Beall's Mount: Preliminary Plan No. 120160230

Staff Report Date: 11/28/16

Request to subdivide an unrecorded parcel to create three lots for three detached single-family dwellings; located at 12220 Stoney Creek Road, 500 feet south of Meadow Farm Road; 21.59 acres; RE-2 zone; 2002 *Potomac Subregion Master Plan*.

Staff Recommendation: Approval with conditions.

ATTACHMENT 5

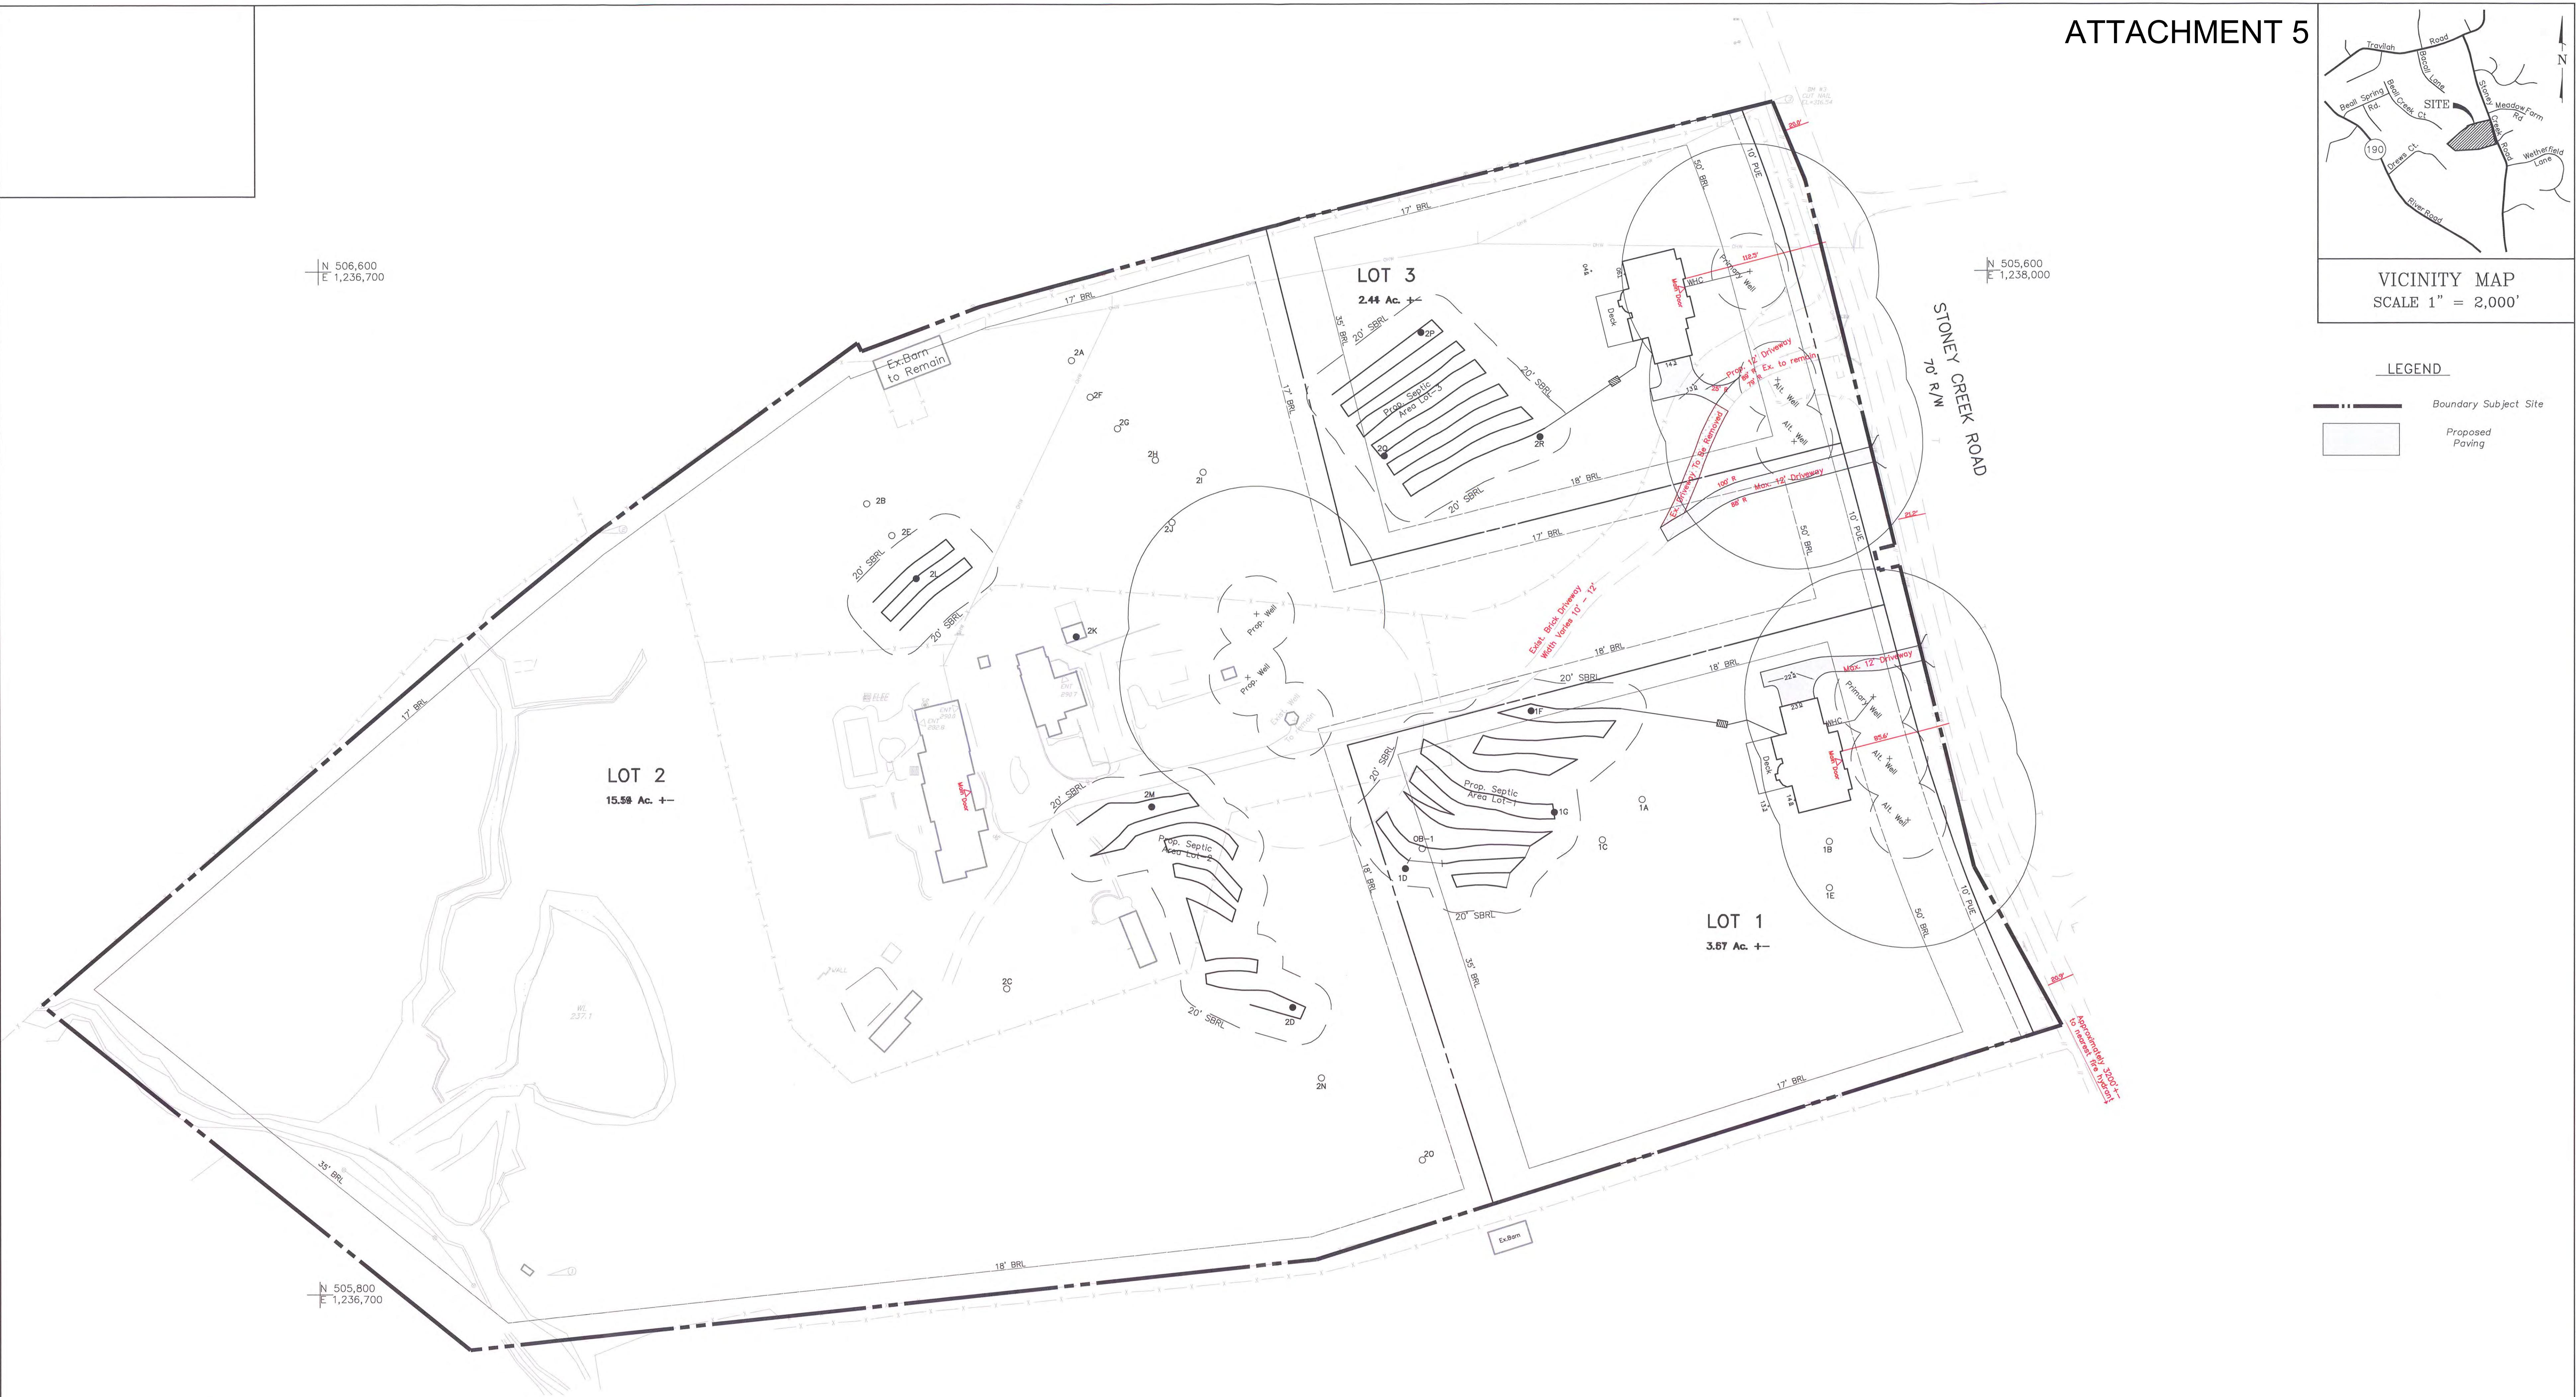
FIRE CODE ENFORCEMENT
Fire Department Access Review
Review based only upon information contained on this plan. Does not cover unsatisfactory layout resulting from omissions, errors or failure to clearly indicate conditions on this plan. Correction of unsatisfactory layout to afford required access will be required if found upon inspection after installation
BY: 34C FM: 43 DATE: 6/16/16
